REASON FOR APPEAL

FILE: BZZ-433

February 4, 2002

RE: Baja Riverside Site Plan Review

EXHIBIT
"B"

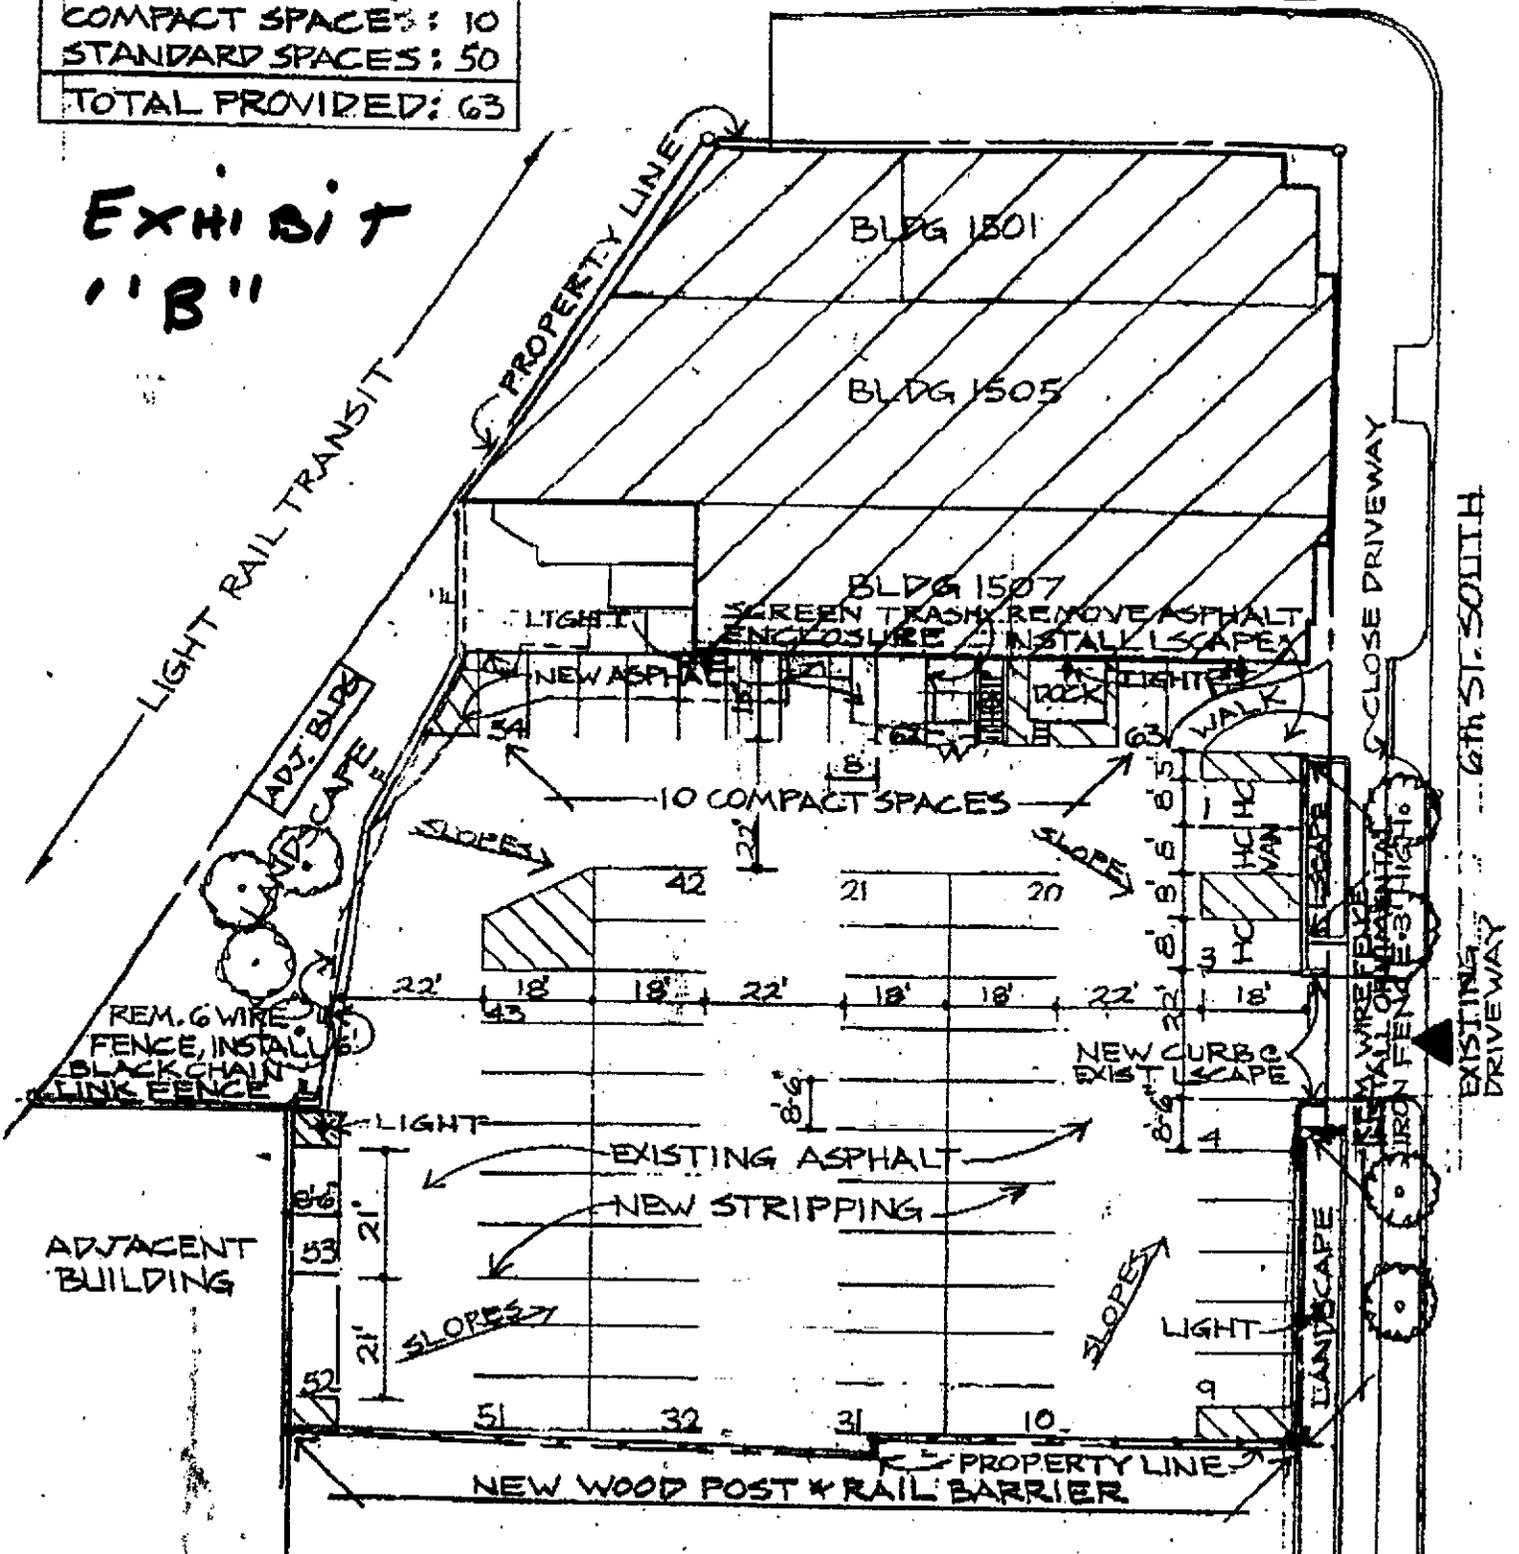
Secondly, you will see in a report later in this Appeal, from Alliant Engineering, stating that the January 21, 2002 site plan design for stall size and number of stalls is inaccurate and does not meet the standards. The site plan in the report is very different from the one viewed by Public Works, Fire and Police Departments and other departments. Both site plans are attached as Exhibits A and B.

Further, the staff report states that it "appears" that the site can provide 63 stalls. This is simply not factual. It even goes on to state that the handicapped spaces do not have proper dimensions. This is accurate.

The original site plan submitted several months ago showed 59 parking spaces. The new "Revised Site Plan" shows 63 spaces. The inaccuracies pointed out in Alliant Engineering's report would reduce the number of stalls to something less than 63. It would be 59 in some configuration and possibly less in others.

SITE PLAN

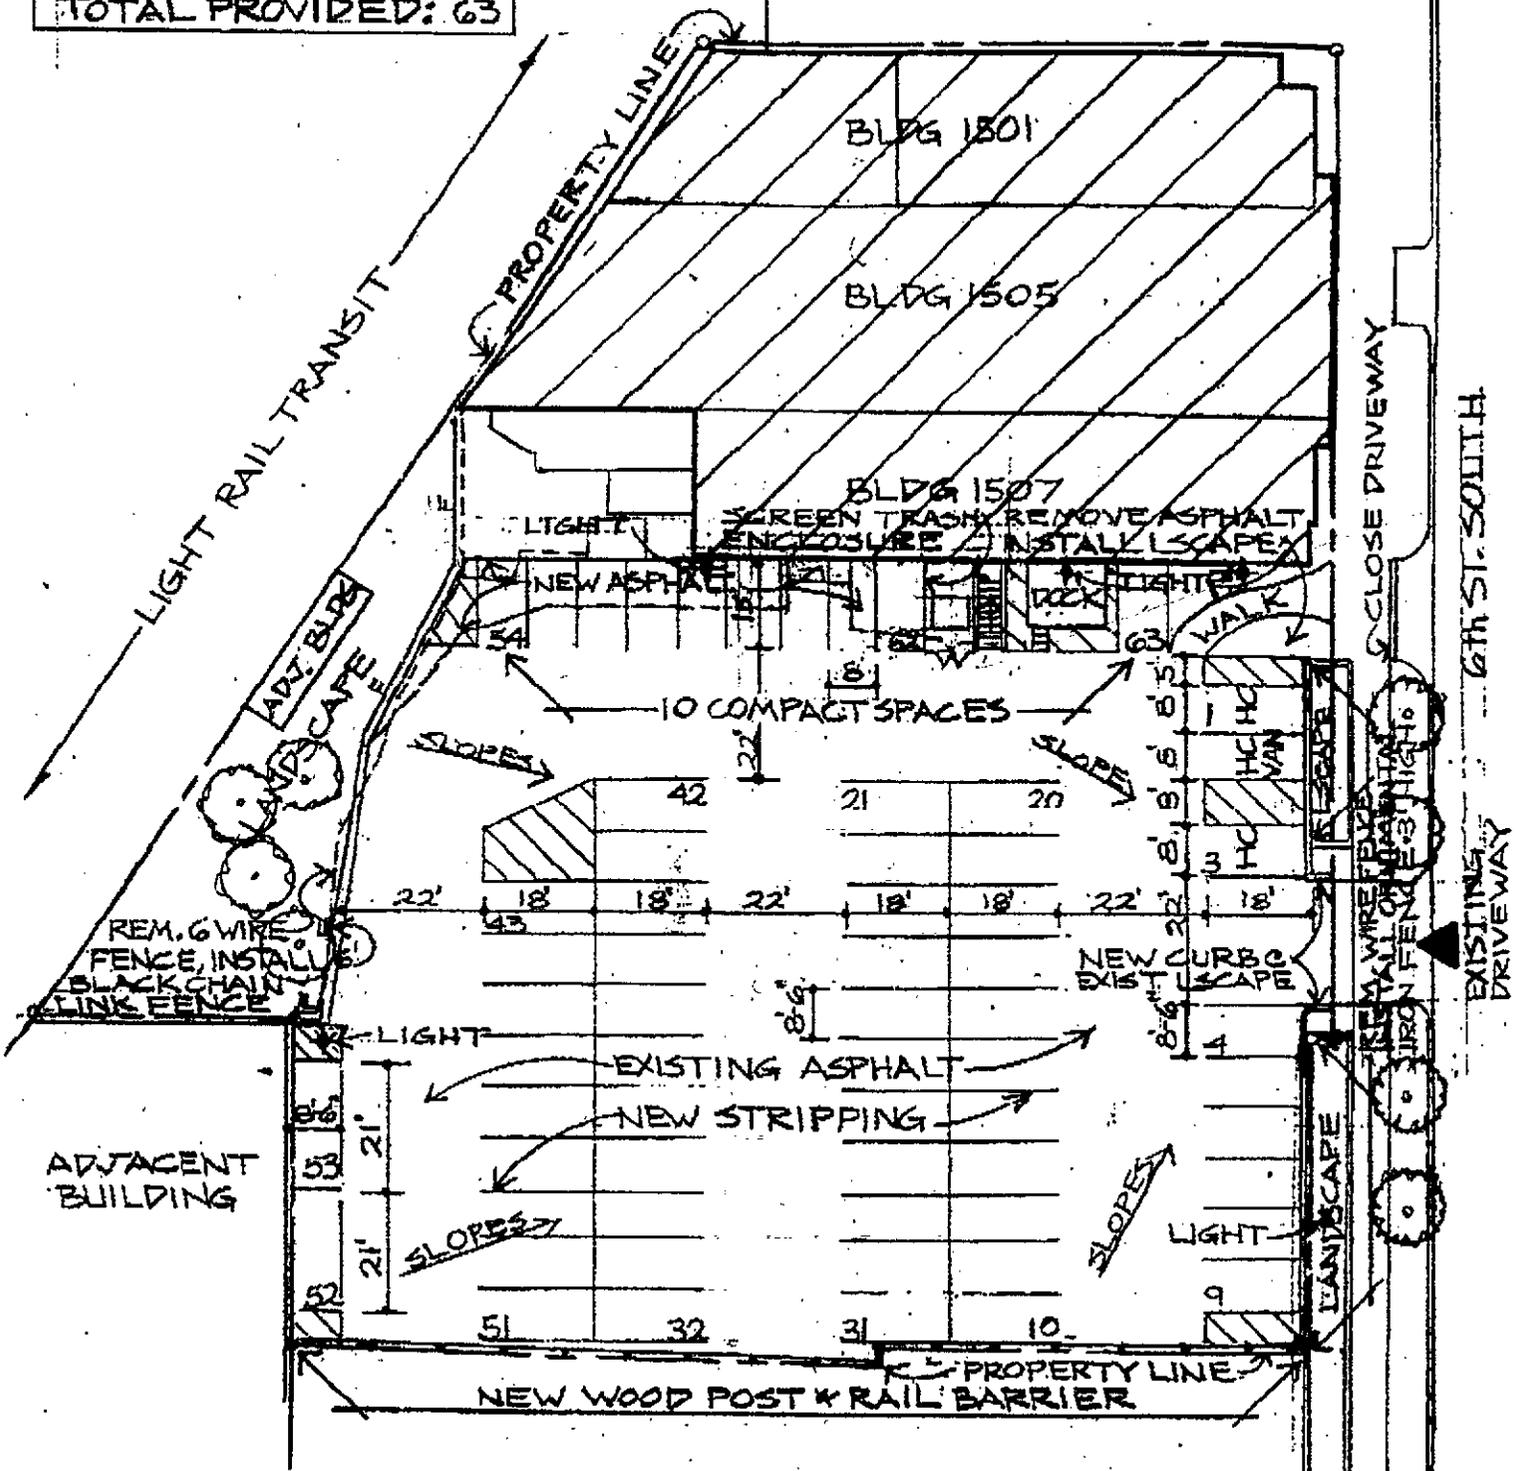
- The horizontal dimension string running through the body of the parking field has discrepancies in length based on the required stall depths. It should be noted that the two parallel and vertical banks of parking stalls located within the central portion of the parking field each are required to be thirty-six (36) feet in width (18'+18'). The west (left) bank measures thirty-five (35) feet while the east (right) bank measures thirty-three (33) feet across which is a difference of two (2) feet. While this may be the result of preparing the Site Plan by hand the difference is significant due to the limited space available to provide the required parking. Furthermore, the total of the dimension string required along the bottom of the parking field furthest away from the proposed restaurant based on the current lot configuration is 164.5 feet (8.5'+22'+18'+18'+22'+18'+18'+22'+18') while the lot width measures approximately 159 feet +/- . Therefore, a reduction in parking and/or landscaping should be anticipated. It also our opinion that the drawing is not drawn to scale.

- The horizontal dimension string running through the body of the parking field appears to begin a few feet into the proposed landscape areas located adjacent to 6th Street South at the parking lot entrance. This will result in the handicapped parking stalls being less than eighteen (18) feet which is required by the City of Minneapolis Zoning Code. Shifting of the dimension string further to the west (left side of the drawing sheet) may result in a reduction of parking.
- The parallel parking stall identified as "52" on the Site Plan and located near the bottom left corner of the parking field will be extremely difficult to access due to its proximity to the south (bottom) property line if a vehicle is already occupying stall no "53".

The current Site Plan proposes to sheet drain stormwater across the proposed parking field towards the parking lot entrance and onto 6th Street South right-of-way. As a result, approximately 2.5 cubic feet per second (approximately 19 gallons per second) of stormwater will be concentrated at the parking lot entrance and drain across the sidewalk for a rainfall event with a return frequency of one year which is common.

The City of Minneapolis Zoning Code, Section 541.310 states "Water from the parking area shall not drain across a public walkway."
